Watts Bar Nuclear Plant, Unit 2
NRC Docket No. 50-391

Subject: Watts Bar Nuclear Plant (WBN) Unit 2 – Response to Request for Additional Information (RAI) Regarding June 28, 2011 NRC Audit – Steam Line Break (SLB) and other Miscellaneous RAIs

Watts Bar Unit 2 Completion Program – Responses to Additional NRC Non-LOCA RAIs

Enclosure 3
TVA Letter Dated July 29, 2011
FSAR mark-ups for SLB transients

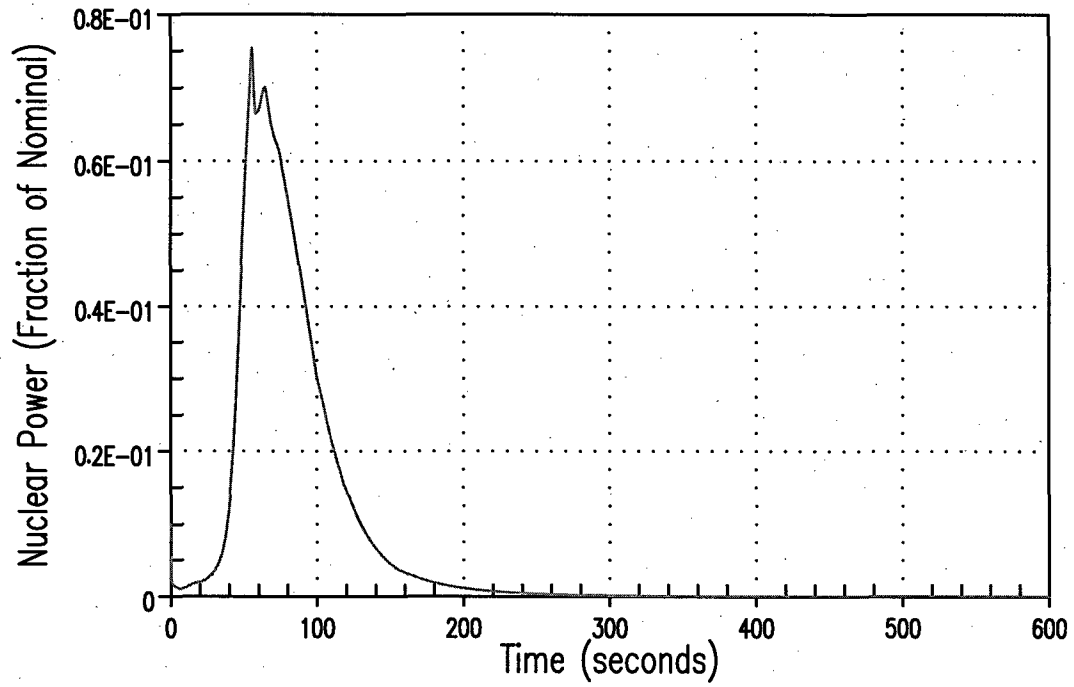
1. The licensing basis hot zero power steamline break analysis for Watts Bar Unit 2 results in a peak heat flux of 1.6%. The Watts Bar Unit 1 licensing basis analysis results in a peak heat flux of 4.4%. Since the two plants are nearly identical (Unit 1 has replacement steam generators and has had a small uprate), their steamline break results should be similar. The purpose of this document is to quantitatively identify the differences between the two analyses and the impact on peak heat flux of each difference.

The Zero Power Steamline break analysis for Unit 2 (Watts Bar Unit 1 prior to the steam generator replacement program) was taken as the starting point. Incremental changes were made to the input deck to demonstrate the impact of the various changes on the analysis. The table below describes the changes made and the effect on peak power.

The results of this table show that the Unit 2 analysis assumed a less limiting Doppler temperature coefficient, which contributed to the lower return to power. The difference in steam generator types resulted in a small benefit in the analysis. When the differences in steam generator types and reactivity coefficients are accounted for the Unit 2 heat flux is within 0.6% of the Unit 1 heat flux. The majority of the remainder of the difference is due to the pump heat modeled. The Unit 1 analysis models a bounding minimum pump heat, where the Unit 2 analysis does not take credit for any pump heat. The pump heat modeled in both analyses is conservative compared to the expected pump heat.

Watts Bar Unit 2 Hot Zero Power Steam Line Break with Offsite Power Available –Nuclear Power Versus Time

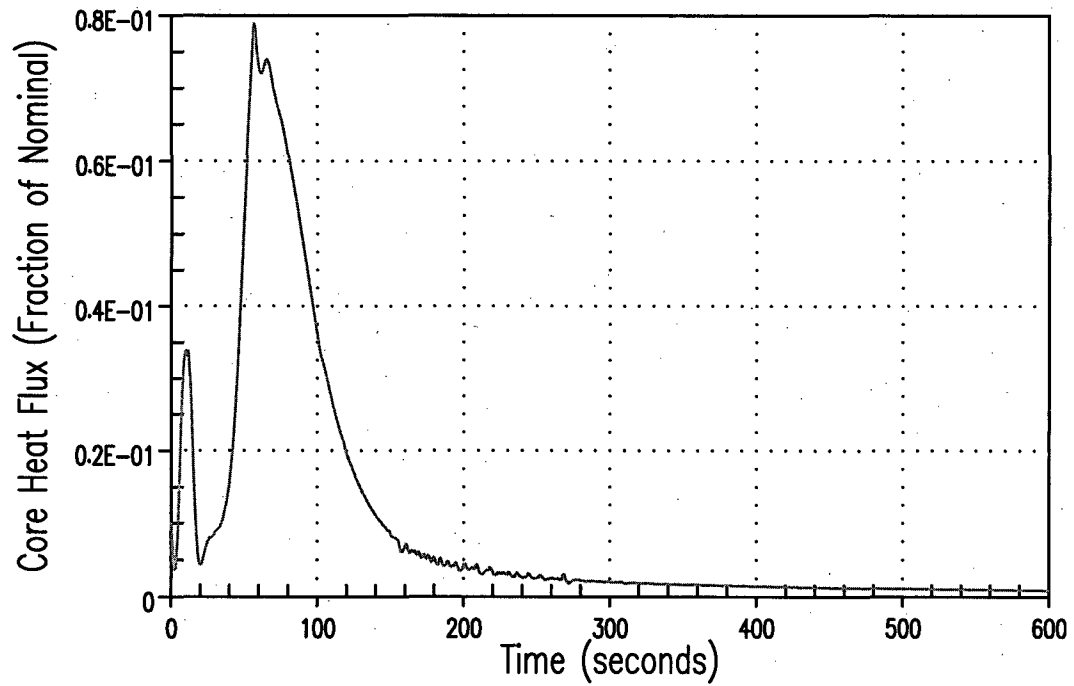
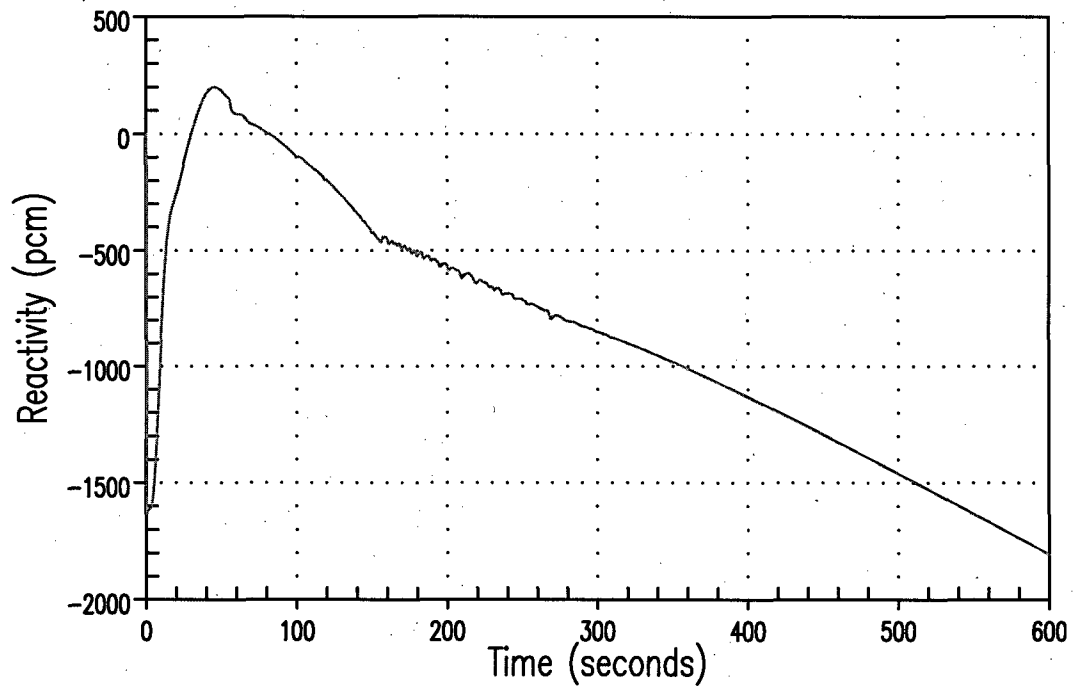
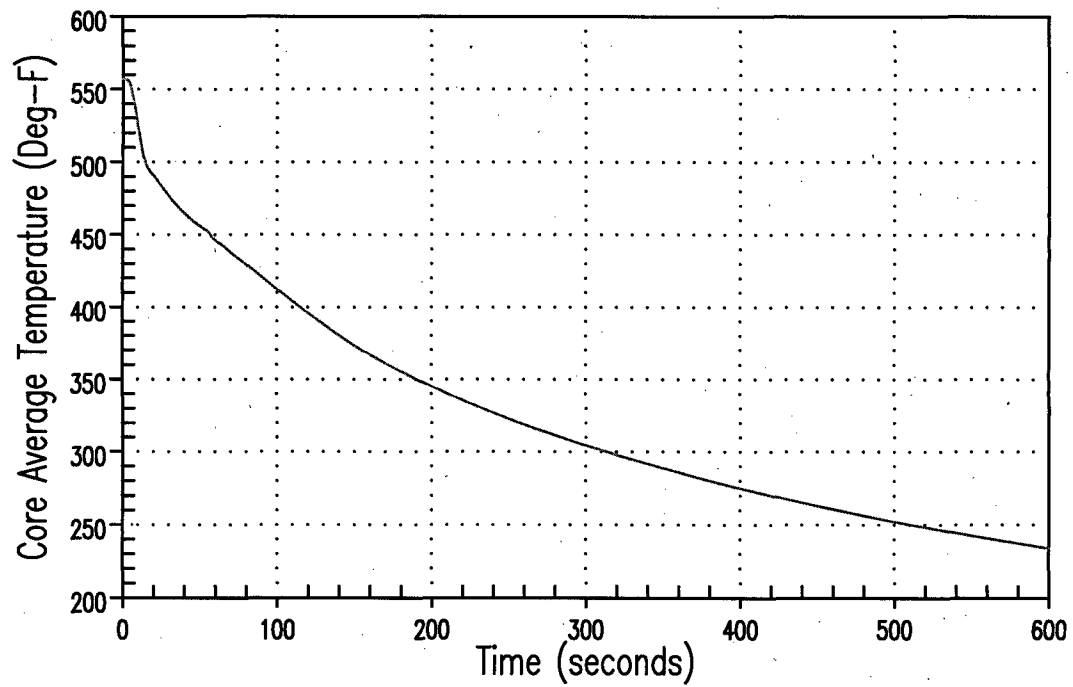
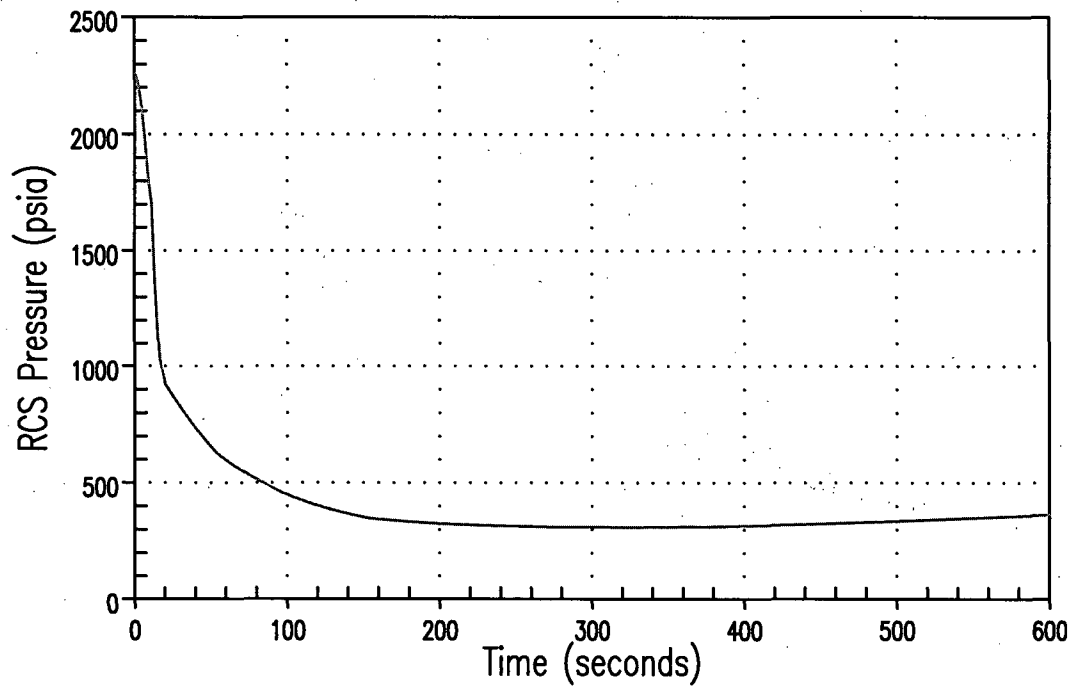
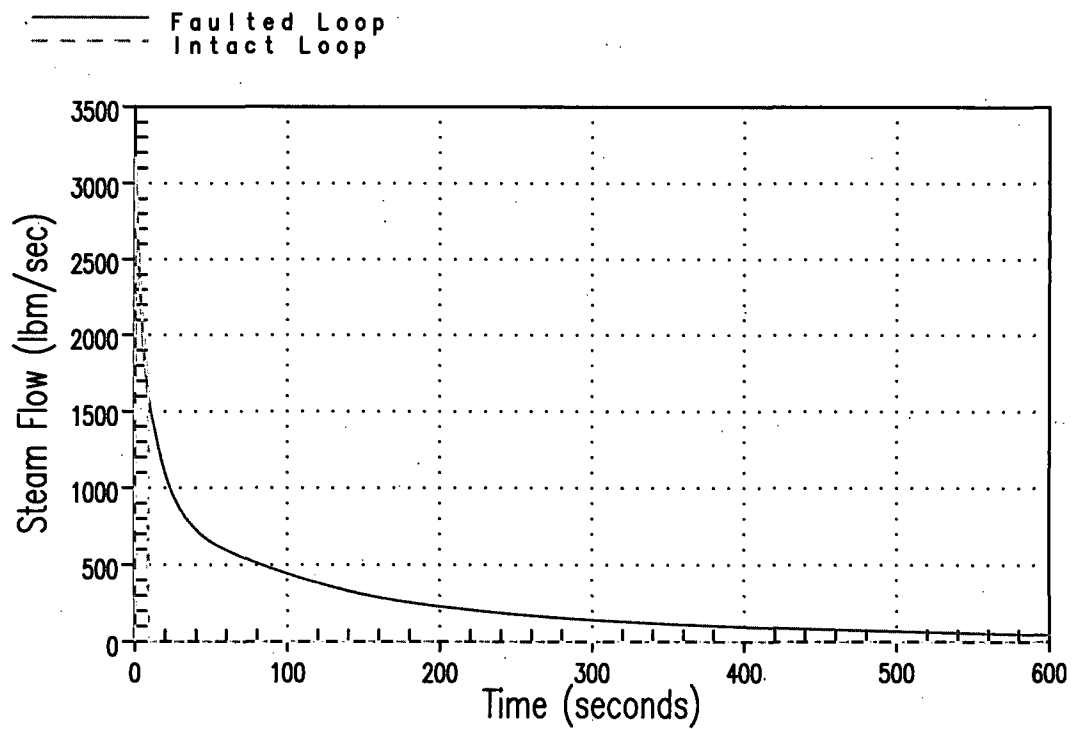
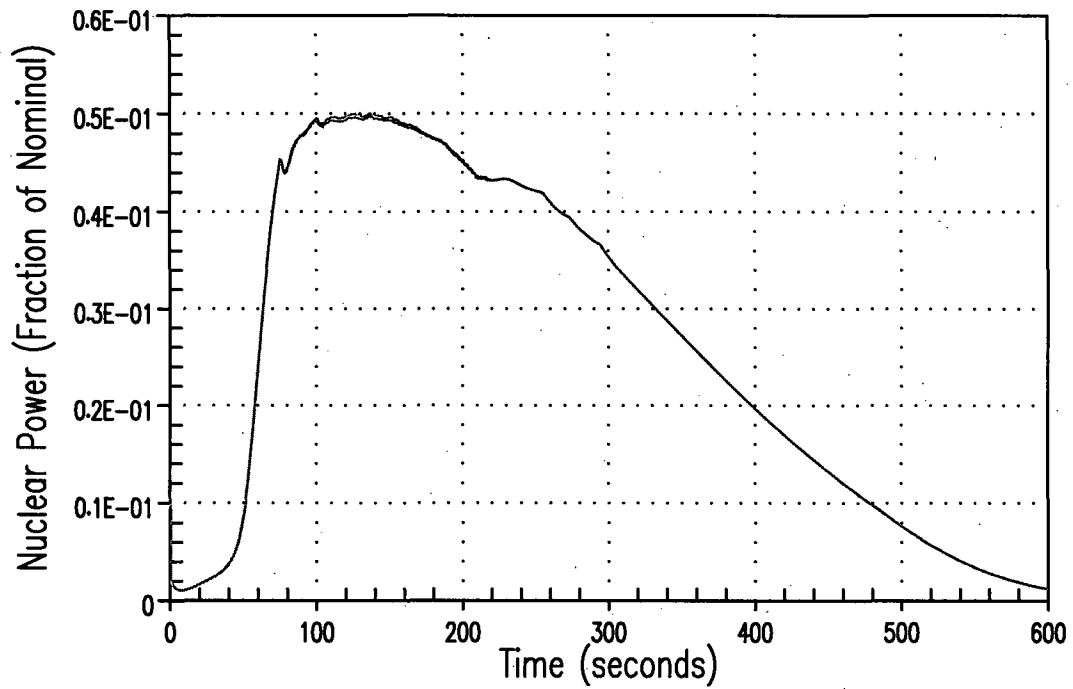
3. The Watts Bar Unit 2 analysis was revised to model the Doppler temperature coefficient that was used in the Unit 1 RSG analysis. This resulted in the peak power in the with offsite power case that is greater than the peak power in the without offsite power case. The limiting statepoint for the with and without offsite power cases are presented below along with a table which lists the sequence of events for each case. Additional plots of the key transient parameters are presented on the following pages.

Figure 15.4-9 Variation of Reactivity with Power at Constant Core Average Temperature

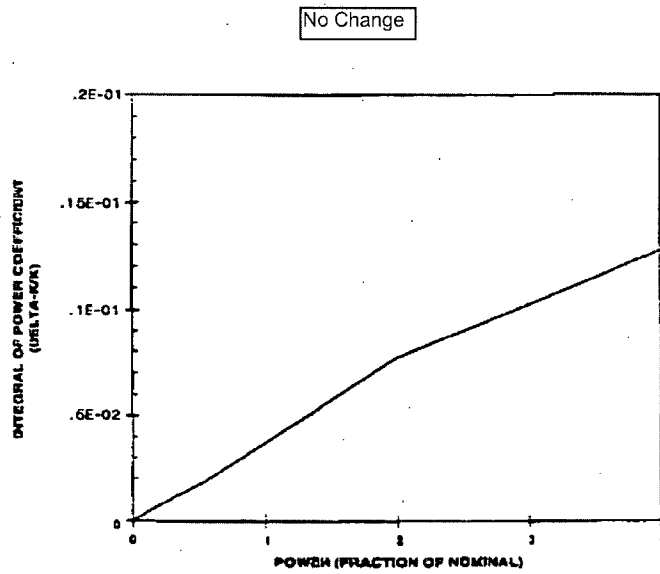
The integral of the Doppler Power Coefficient is shown in Figure 15.4-9 and a Doppler Temperature Coefficient of -0.000029 $\Delta k/^{\circ}F$ was assumed.

Figure 15.4-11a Transient Response to Steam Line Break with Safety Injection and Offsite Power (CASE A)

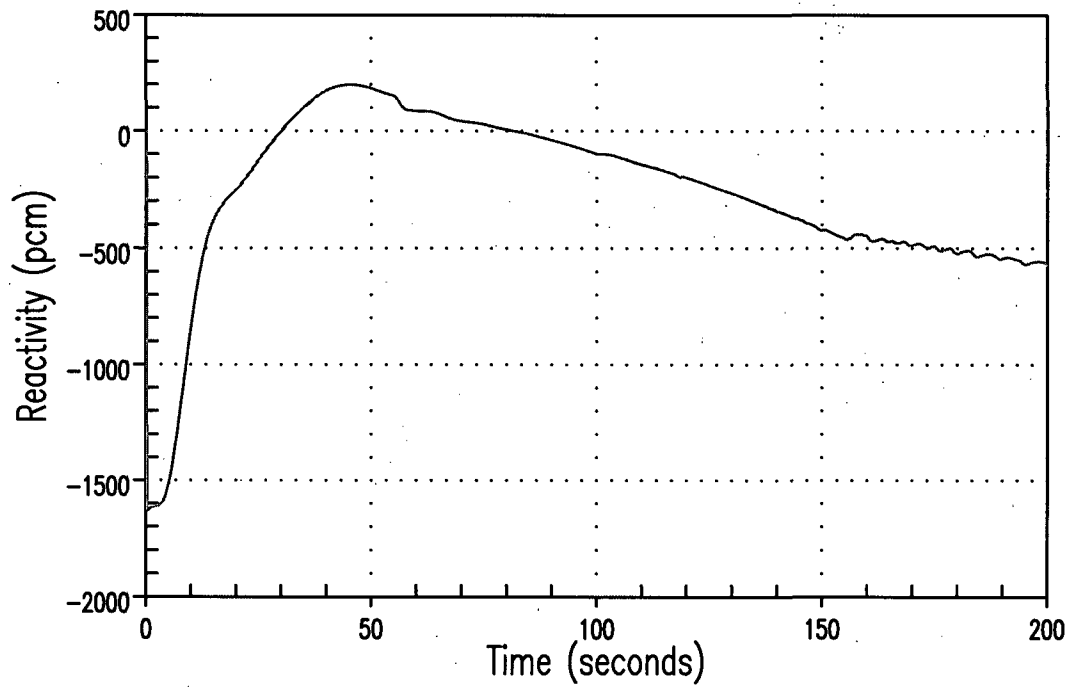
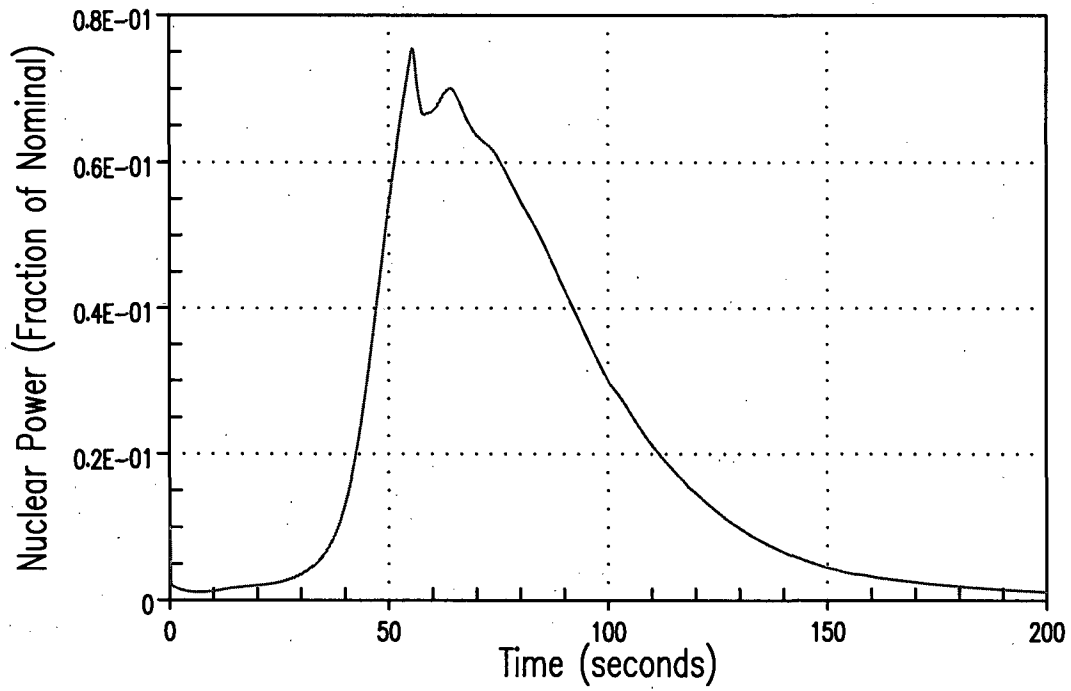
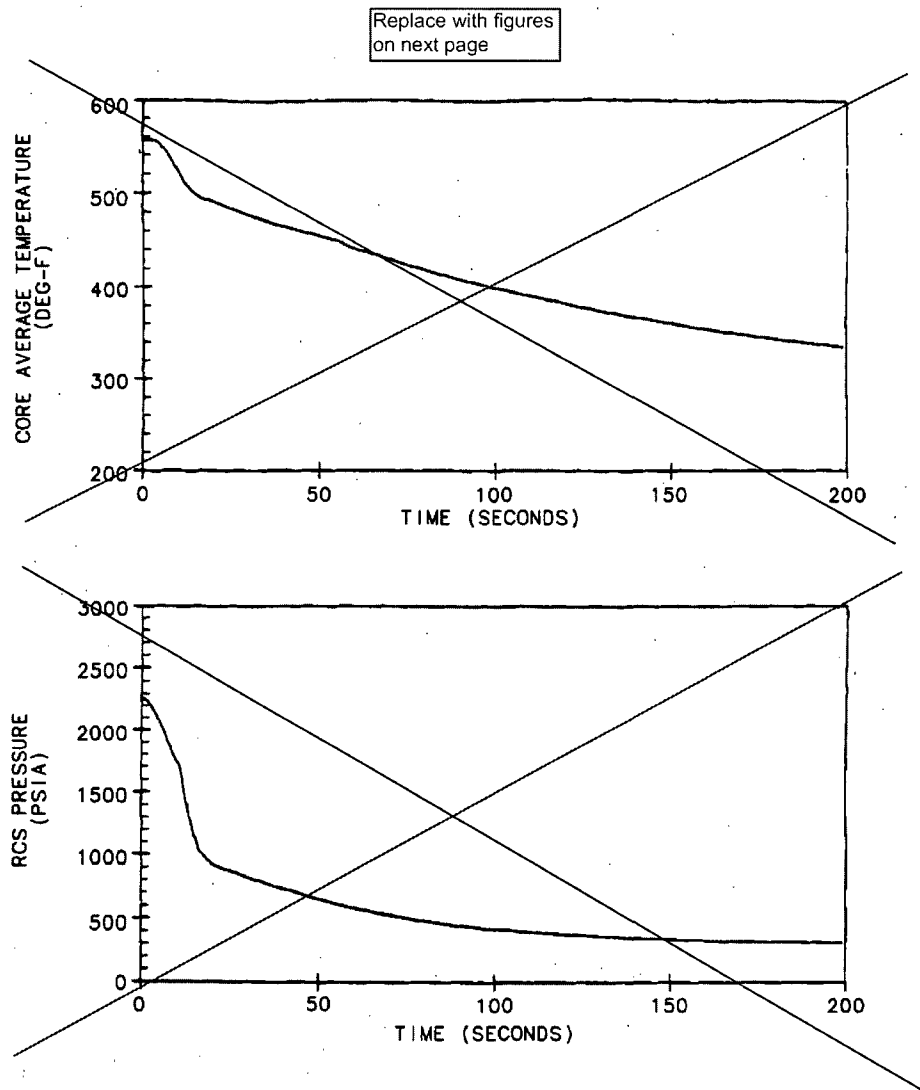
Figures 15.4-11a through 15.4-11c show the RCS transient and core response following a main steam line rupture (complete severance of a pipe) at initial no load condition (Case a). Offsite power is assumed available so that full reactor coolant flow exists. The transient shown assumes an uncontrolled steam release from only one steam generator. Should the core be critical at near zero power when the rupture occurs the initiation of safety injection by low steamline pressure will trip the reactor. Steam release from more than one steam generator will be prevented by automatic trip of the fast acting isolation valves in the steam lines by high-high containment pressure or low steam line pressure signals. Even with the failure of one valve, release is limited by isolation valve closure for the other steam generators while the one generator blows down. The main steamline isolation valves are designed to be fully closed in less than 6 seconds from receipt of a closure signal.

As shown in Figure 15.4-11a the core attains criticality with the RCCAs inserted (with the design shutdown assuming one stuck RCCA) shortly after boron solution at 2000 ppm (which is bounding for higher boric acid concentrations) enters the reactor coolant system. A peak core power less than the nominal full power value is attained.

Replace with figures
on next page
